**SPECIAL PROVISIONS  
FOR  
MULTI-COMPONENT LIQUID PAVEMENT MARKINGS**

**Jasper County  
IM-NHS-080-5(304)174--03-50**

**Johnson County  
IM-NHS-080-7(174)248--03-52**

**Effective Date  
December 21, 2021**

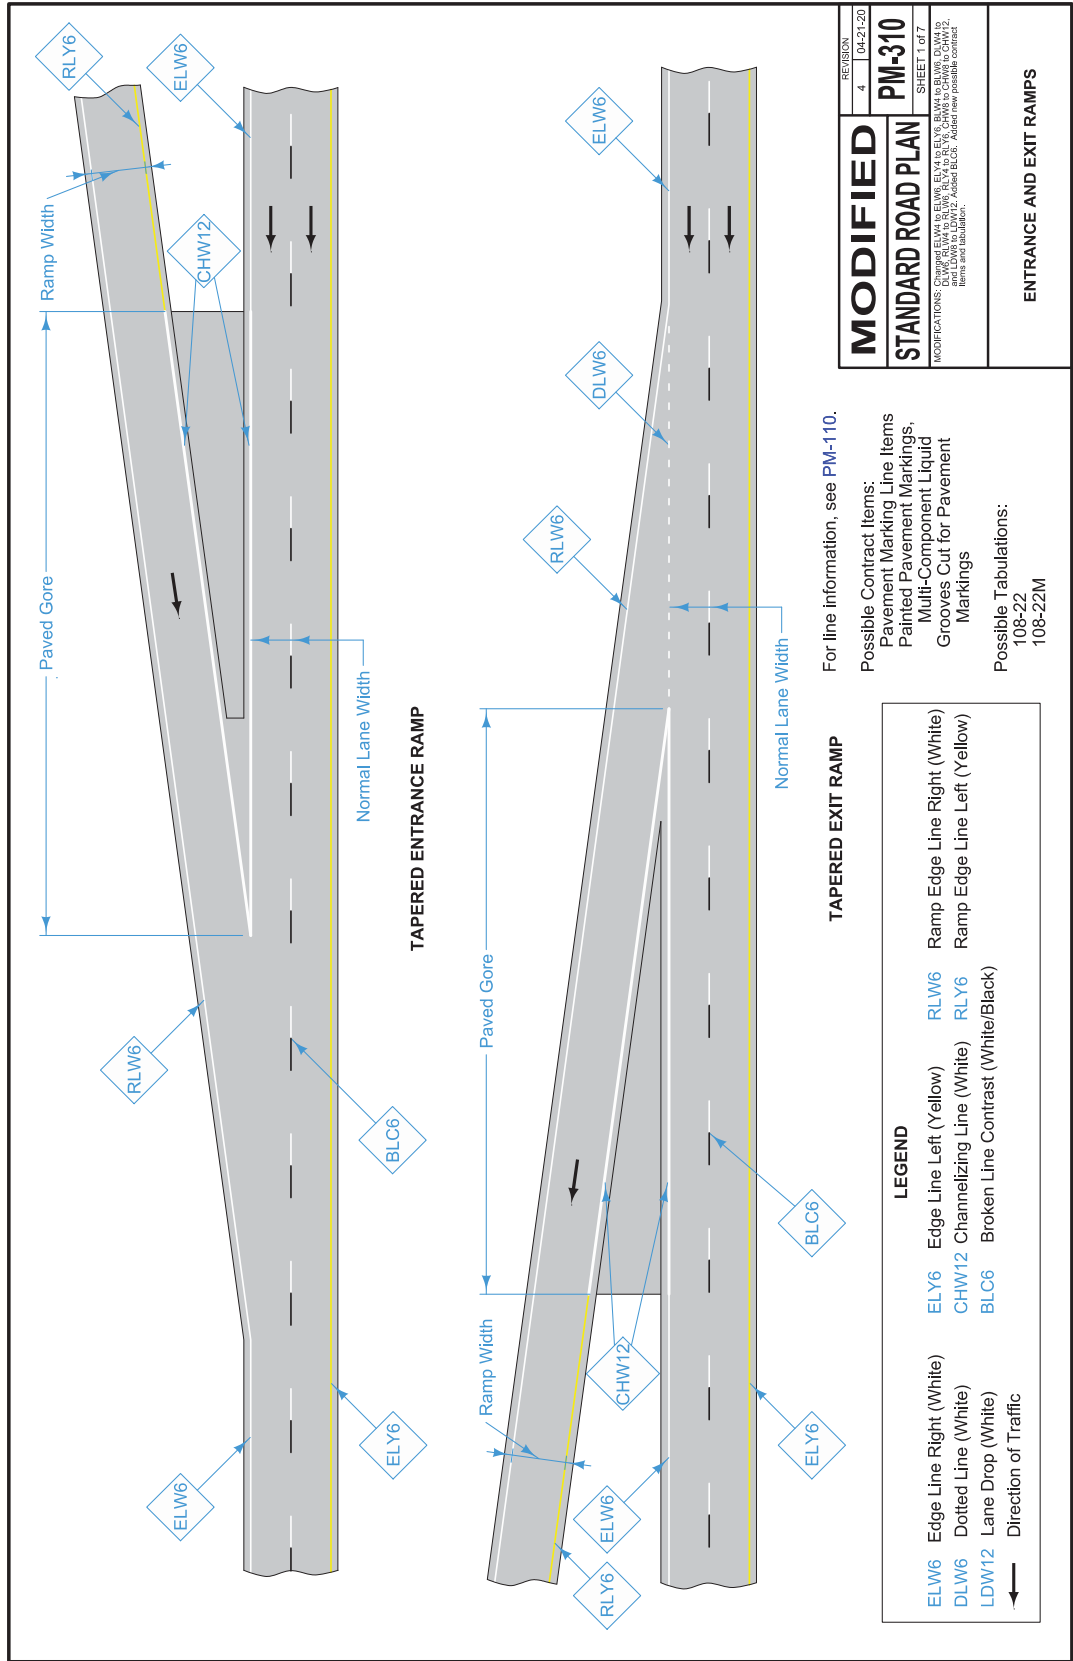
<b>MODIFIED</b>	REVISION	4	04-21-20
	<b>PM-310</b>	SHEET 1 of 7	
<b>STANDARD ROAD PLAN</b>	MODIFICATIONS: Changed ELW6 to ELW6, ELY6 to ELY6, BLY6 to BLY6, DLY6 to DLY6, DLW6 to DLW6, RLY6 to RLY6, CHW12 to CHW12, BLC6 to BLC6, and added new pavement contract items and tabulations.		
<b>ENTRANCE AND EXIT RAMP</b>

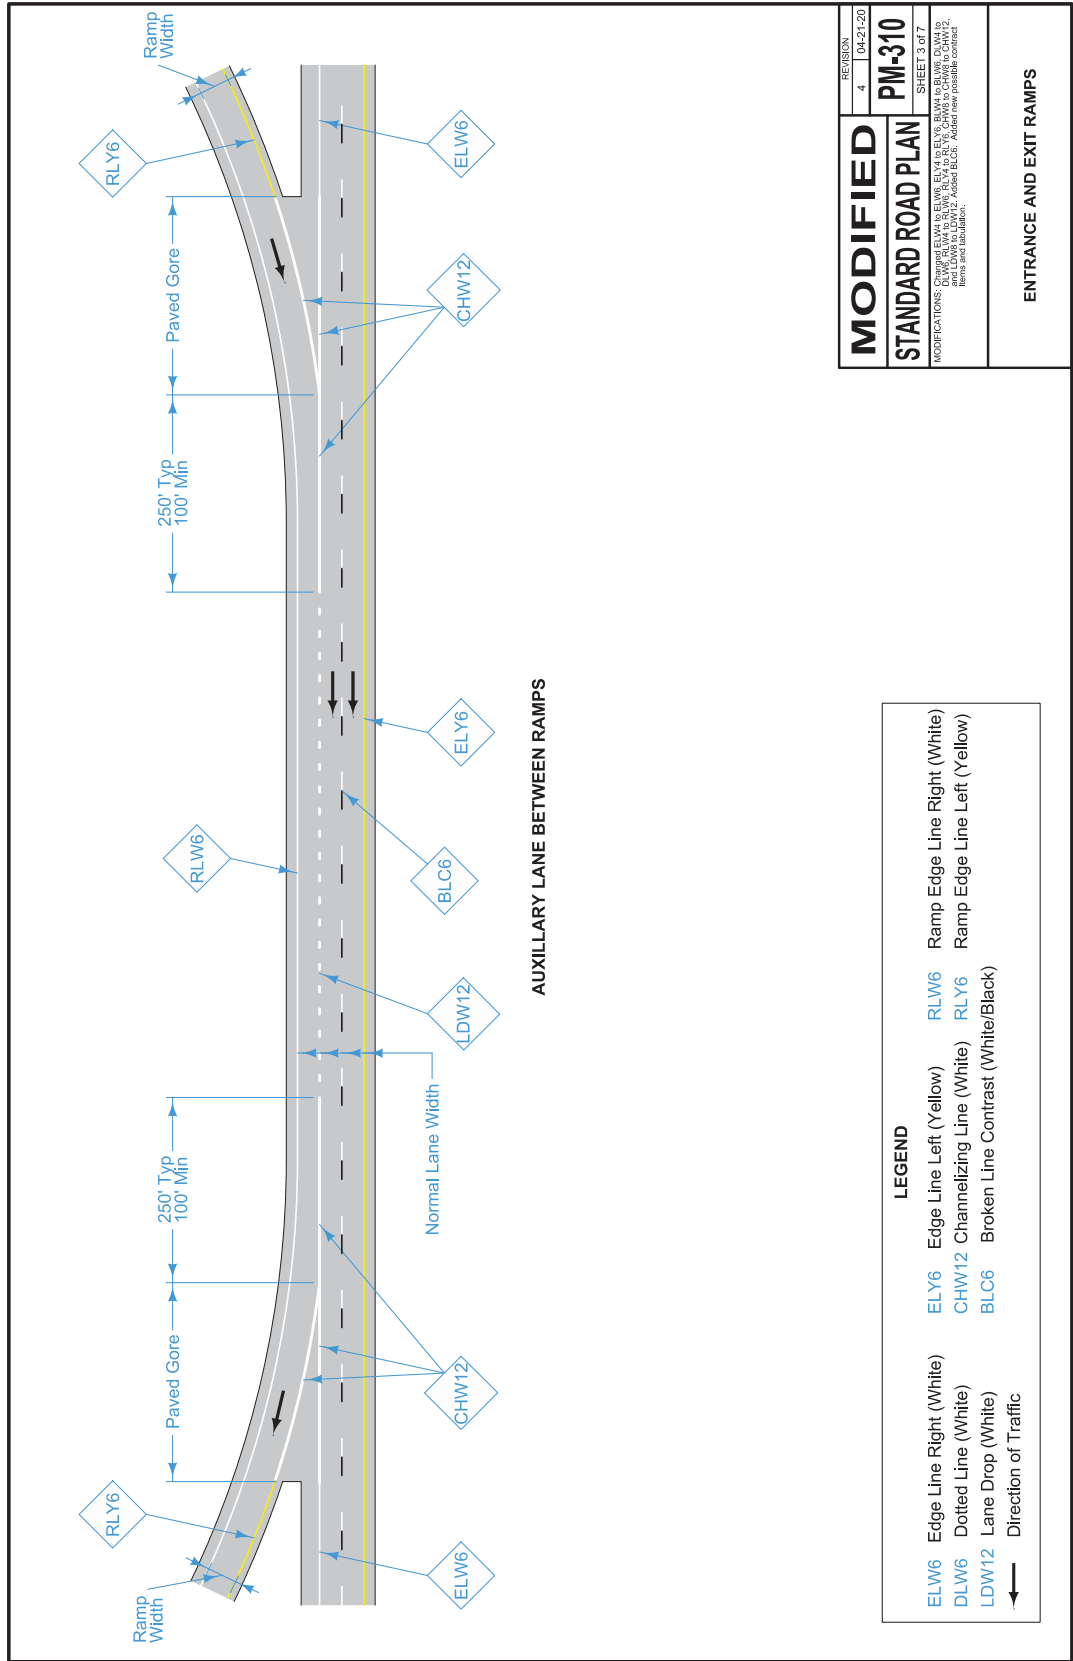
<b>MODIFIED</b>	REVISION 4	DATE 04-27-20
	<b>PM-310</b>	
<b>STANDARD ROAD PLAN</b>		
MODIFICATIONS: Changed ELW6 to ELW6, ELW4 to ELW6, BLM6 to ELW6, DMW6 to DLW6, RLY6 to RLY6, RLY6 to RLY6, CHW6 to CHW6 to CHW12, BLM6 to BLM6, BLM6 to BLM6, Added new private contract items and fabrication.		
<b>ENTRANCE AND EXIT RAMP</b>

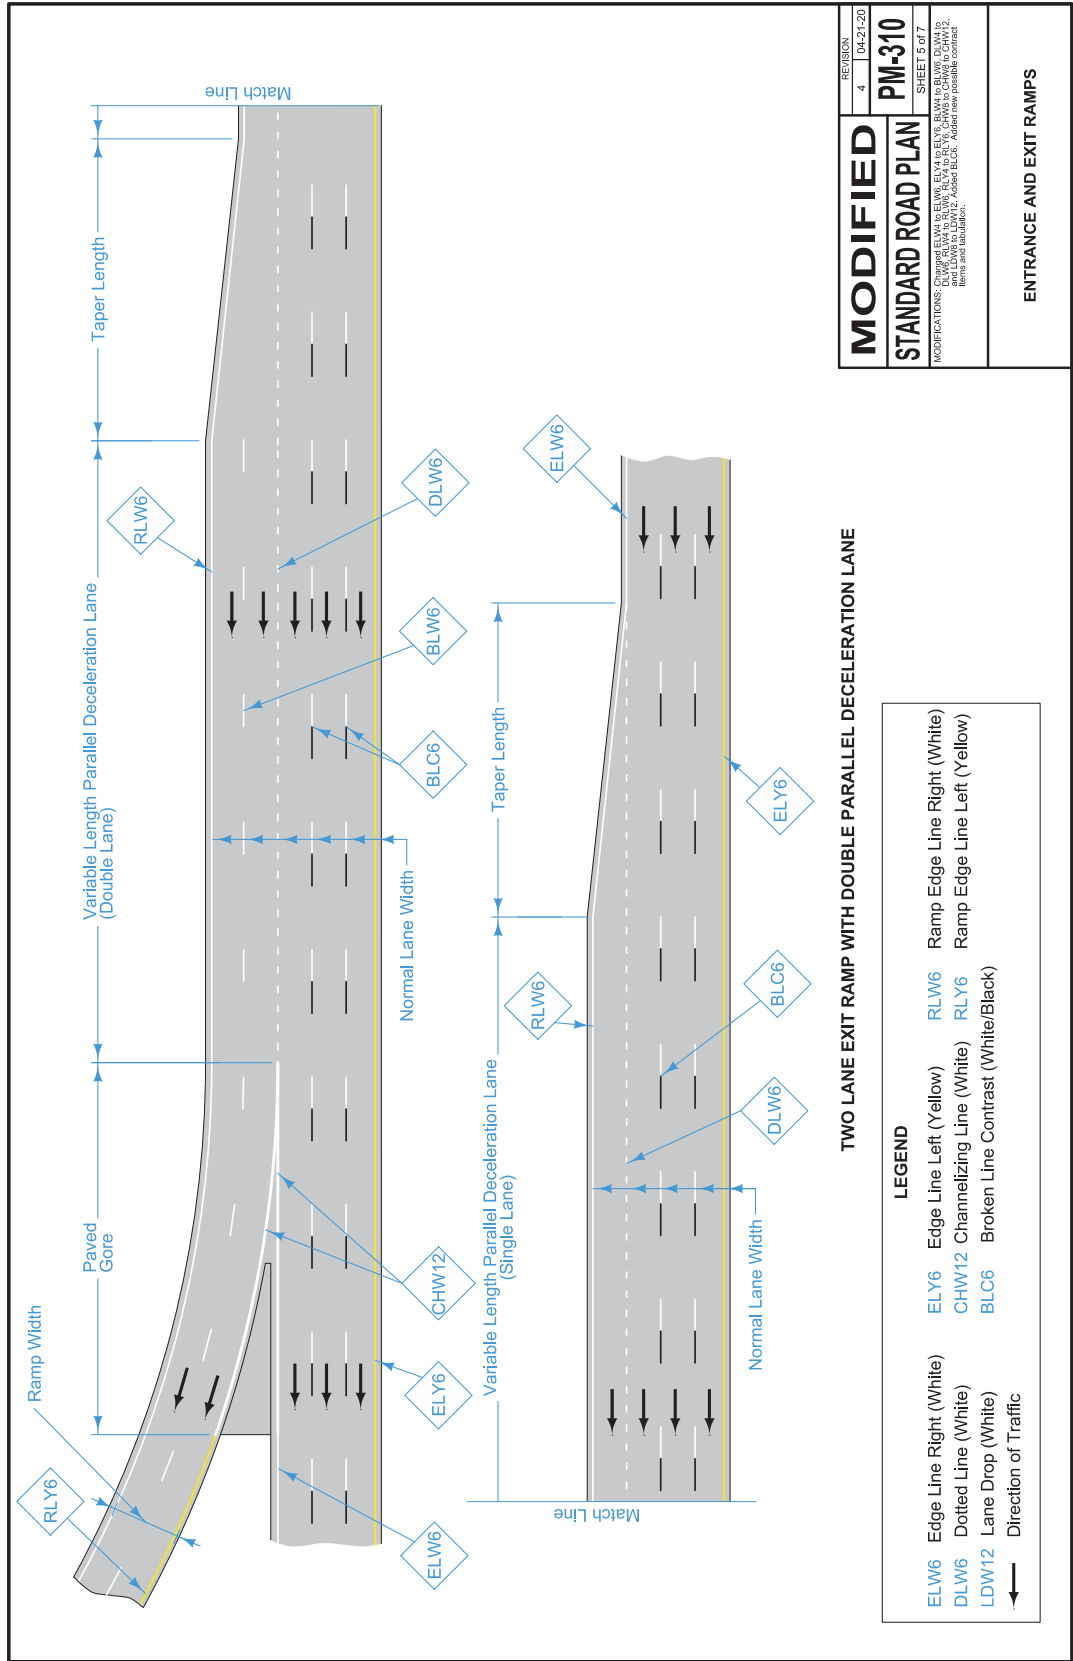
<b>MODIFIED</b>	REVISION	4	04-27-20
	<b>STANDARD ROAD PLAN</b>	<b>PM-310</b>	SHEET 5 of 7
<small>MODIFICATIONS: Changed ELW6 to ELY6, ELY6 to ELW6, BLW6 to ELW6, DLW6 to DLW6, RLW6 to RLY6, RLY6 to RLW6, CHW12 to CHW12, LDW12 to LDW12, BLC6 to BLC6, Added new private contract items and tabulation.</small>			
<b>ENTRANCE AND EXIT RAMP</b>

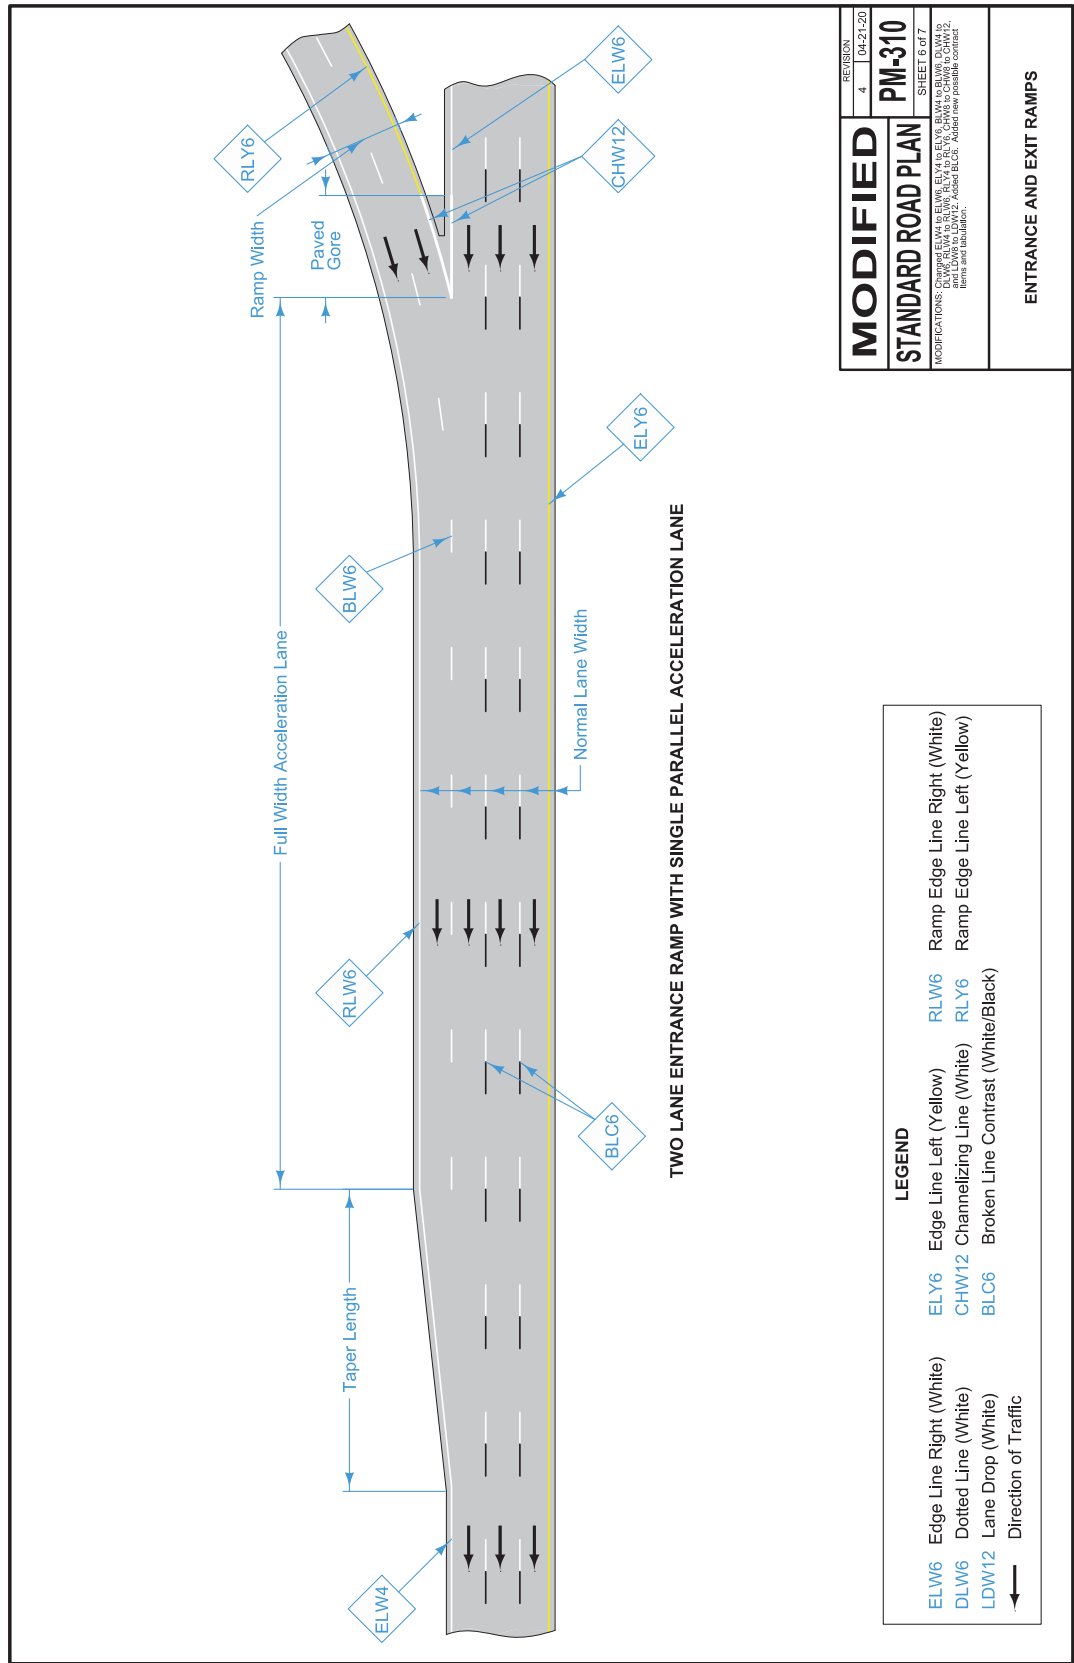
<b>MODIFIED</b>	REVISION	04-27-20
	4	
<b>STANDARD ROAD PLAN</b>		
<b>PM-310</b>		
SHEET 6 of 7		
<small>MODIFICATIONS: Changed ELW6 to ELW6, ELW4 to ELY6, BLW6 to BLW6, DLW6 to DLW6, RLY6 to RLY6, CHW12 to CHW12, CHW6 to CHW6, CHW12 to CHW12, and added BLC6. Added new parallel contract items and tabulation.</small>		
<b>ENTRANCE AND EXIT RAMP</b>

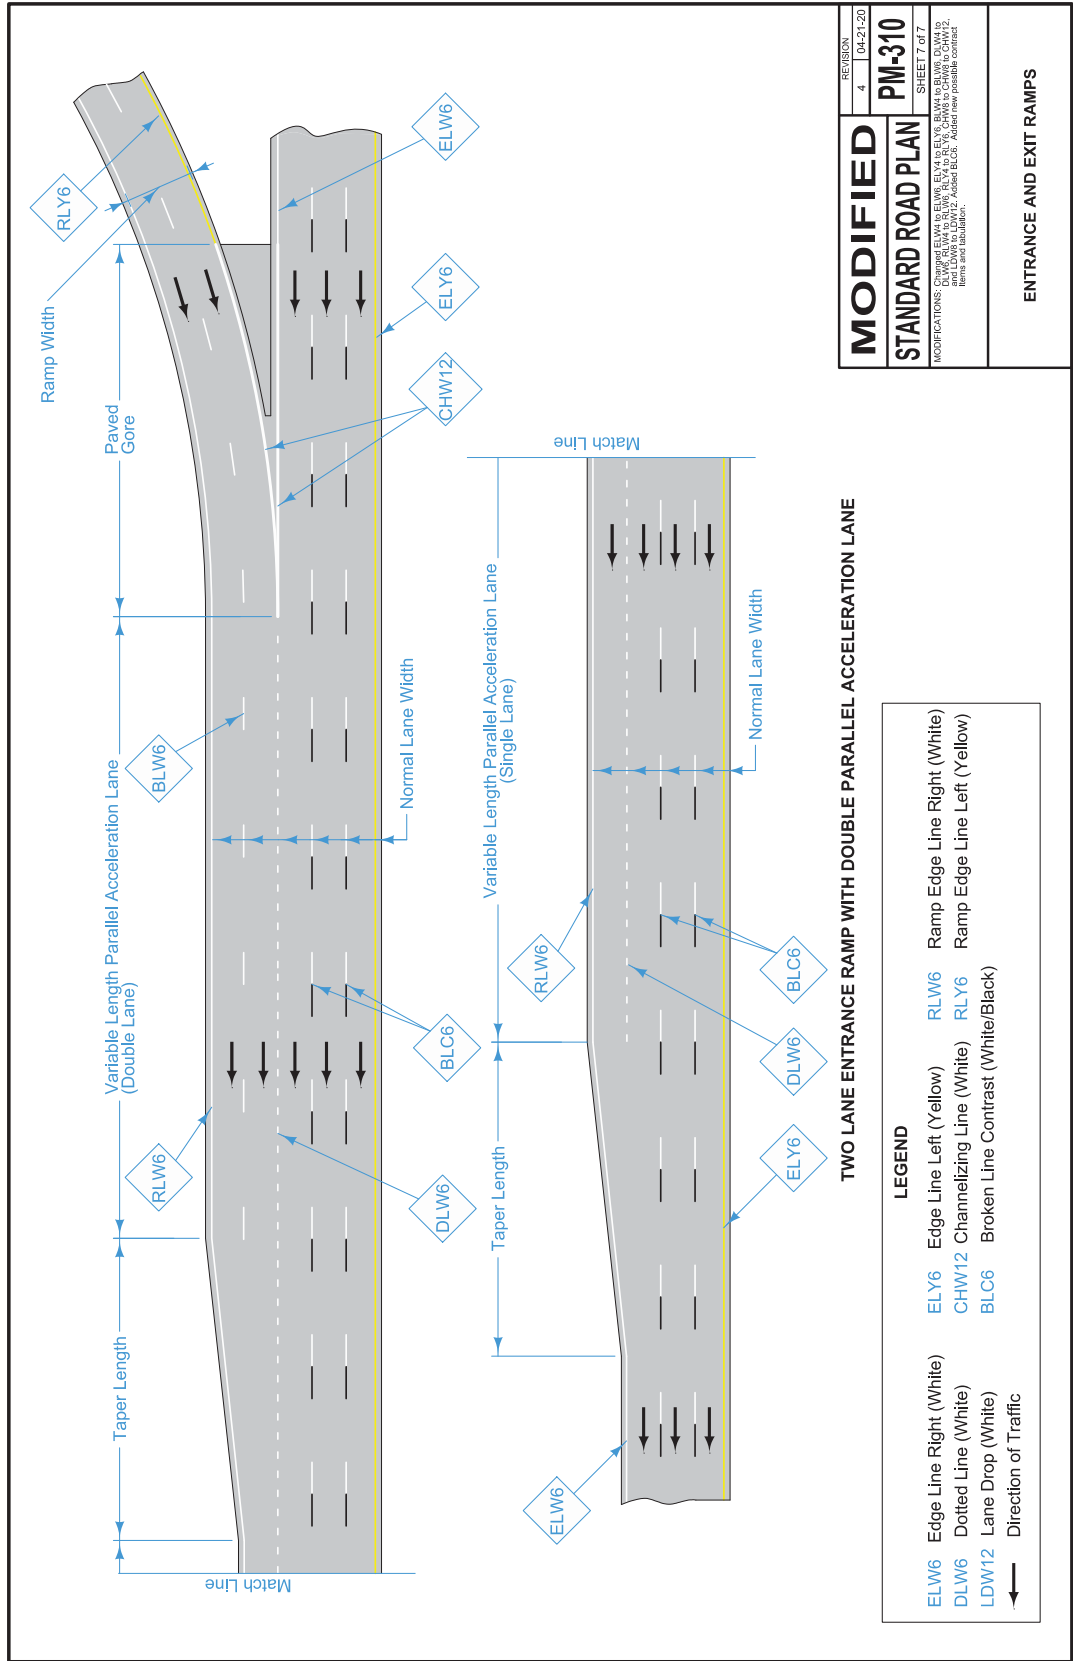
<b>MODIFIED</b>	REVISION	4	04-27-20
	<b>STANDARD ROAD PLAN</b>	<b>PM-310</b>	SHEET 7 of 7
<small>MODIFICATIONS: Changed ELW6 to ELY6, ELY6 to ELW6, BLY6 to BLY6, DLW6 to DLW6, RLY6 to RLY6, CHW12 to CHW12, BLC6 to BLC6, LDW12 to LDW12, and added new parallel contract items and fabrication.</small>			
<b>ENTRANCE AND EXIT RAMPS</b>
